CITY OF ALBUQUERQUE

**RE: Family Dollar
1400 Gibson Blvd SE
Grading Plan
Engineers Stamp Date: 3/9/18 (L15D049)**

FAMILY DOLLAR STORE
GRADING & DRAINAGE PLAN

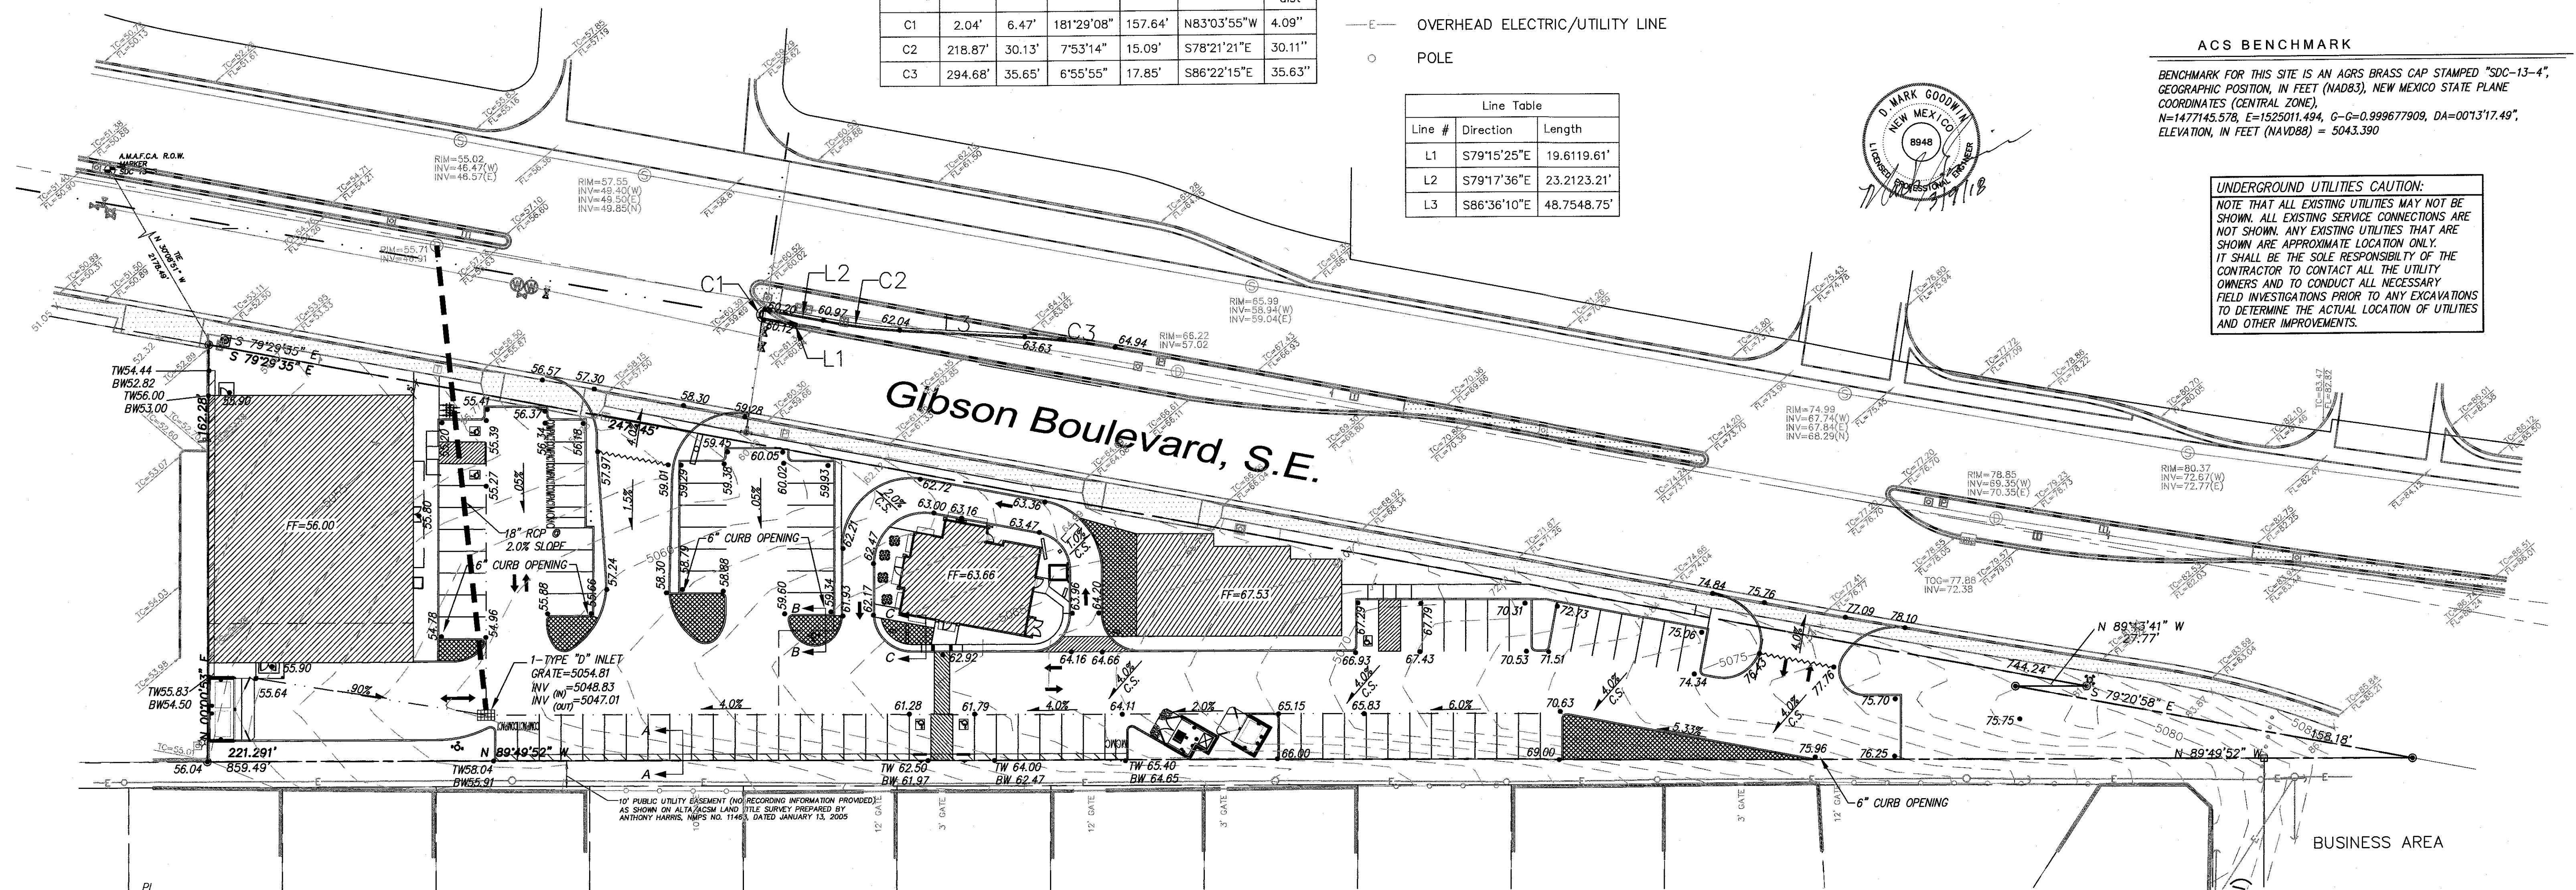
3. Stormwater quality ponds need to be located where they can intercept flows from the impervious areas. Delineate the area draining to each pond, size the pond for the area draining to it, and quantify the first flush volume that bypasses each pond. Payment of Fee-in-Lieu will then be required for the bypass volume at a rate of \$8/cubic foot.

4. Only show phase 1 construction on this plan. Delete or screen back anything to be built in phase 2. This division was partially defined on the previous plan but was removed in this plan.

6. Provide section cuts through the western property line. It appears a new retaining wall is proposed here that will be different from A-A. This will need to demonstrate that no encroachments are being made onto the adjoining property as well. Show existing and proposed grades, the existing walls, property and PUE lines, horizontal and vertical dimensions, including dimensions to property/PUE lines.

7. What is the status of the public work order? Add a note on this plan to the effect of "No work allowed in the public right of way without an approved work order" or similar.
8. The stormwater quality ponds will need private facility drainage covenants.

2. Per the accepted grading plan dated June 15, 2006, the existing 54" storm drain in Gibson was sized to allow fully developed flows from this site.
3. Due to the layout storm water quality ponds could only be obtained in limited portions of the site to address runoff from partial of the roads and buildings. The owners have elected to do a pay in leu to be determined.

4. All the paving is being built with this grading plan for the project. Phase 2 will only incorporate the building pads for the future buildings 2 and 3.

6. Private facility drainage covenants will be completed for the stormwater quality ponds on site.

SECTION A-A

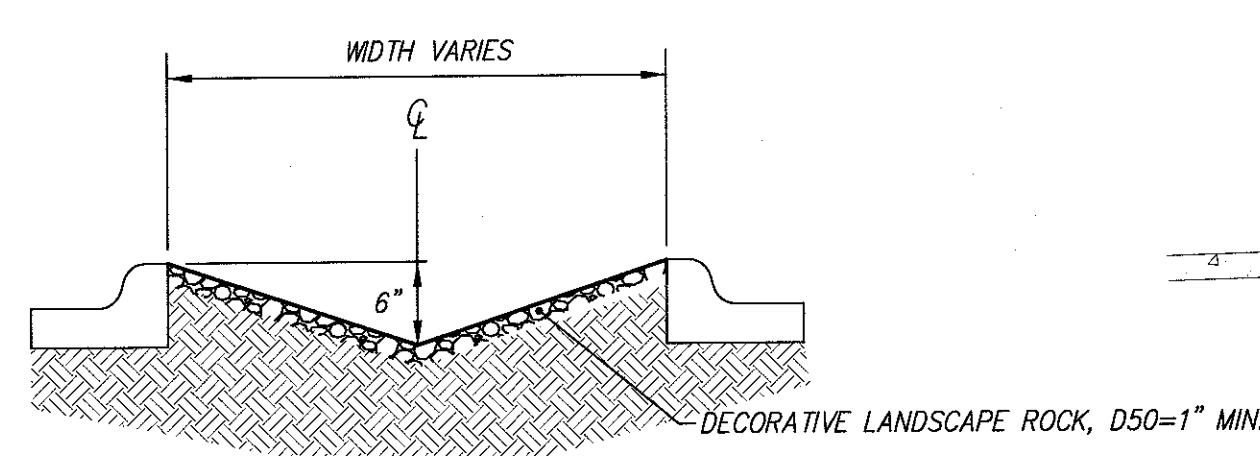
5. Work along the southern boundary needs to be clarified. Extend the section view to show existing and proposed grades, the existing walls, property and PUE lines, horizontal and vertical dimensions, including dimensions to property/PUE lines. If a new wall straddling the property line is required, written permission from the adjoining landowners will need to be obtained. Section A-A seems to indicate a retaining wall footer encroaching on the adjacent property.

5. Work along the southern property line will be maintained within our property only, the retaining wall will be within our site and will not straddle the property line.
